APPLICATION NO.	FILING DATE	FIRST NAMED INVENTOR	ATTORNEY DOCKET NO.	CONFIRMATION NO
10/752,416	01/06/2004	David G. Mikolas	100116	3899
29050 75	590 12/03/2004		EXAMINER	
STEVEN D WESEMAN, ASSOCIATE GENERAL COUNSEL, IP			NGUYEN, GEORGE BINH MINH	
	CABOT MICROELECTRONICS CORPORATION 870 NORTH COMMONS DRIVE		ART UNIT	PAPER NUMBER
AURORA, IL	60504 .		3723	
			DATE MAILED: 12/03/2004	4

M/M			
	Application No.	Applicant(s)	70 0			
	10/752,416	MIKOLAS ET AL.				
Office Action Summary	Examiner	Art Unit				
	George Nguyen	3723				
The MAILING DATE of this communication appeared for Reply	opears on the cover sheet w	ith the correspondence ad	dress			
A SHORTENED STATUTORY PERIOD FOR REP THE MAILING DATE OF THIS COMMUNICATION - Extensions of time may be available under the provisions of 37 CFR 1 after SIX (6) MONTHS from the mailing date of this communication. - If the period for reply specified above is less than thirty (30) days, a re - If NO period for reply is specified above, the maximum statutory perior - Failure to reply within the set or extended period for reply will, by statu Any reply received by the Office later than three months after the mailine earned patent term adjustment.

FIGURE 1A

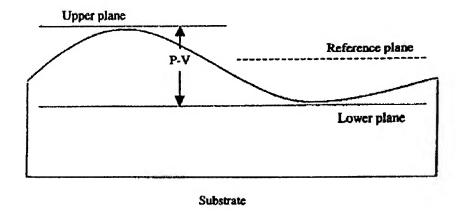
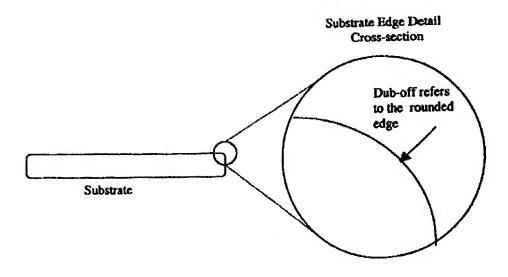
With reference to Figure 2, col. 2, 3 and 8 as shown below discloses the claimed invention. Regarding to claim 4, as well as understood, Baker method comprises a combination of chemical and mechanical polishing. Please note that the prior art "duboff" (col. 10, lines 15-20) is interpreted as "corner rounding". Furthermore, the prior art inherently teaches the "selectively polishing" in order to achieve the improved "dub-off".
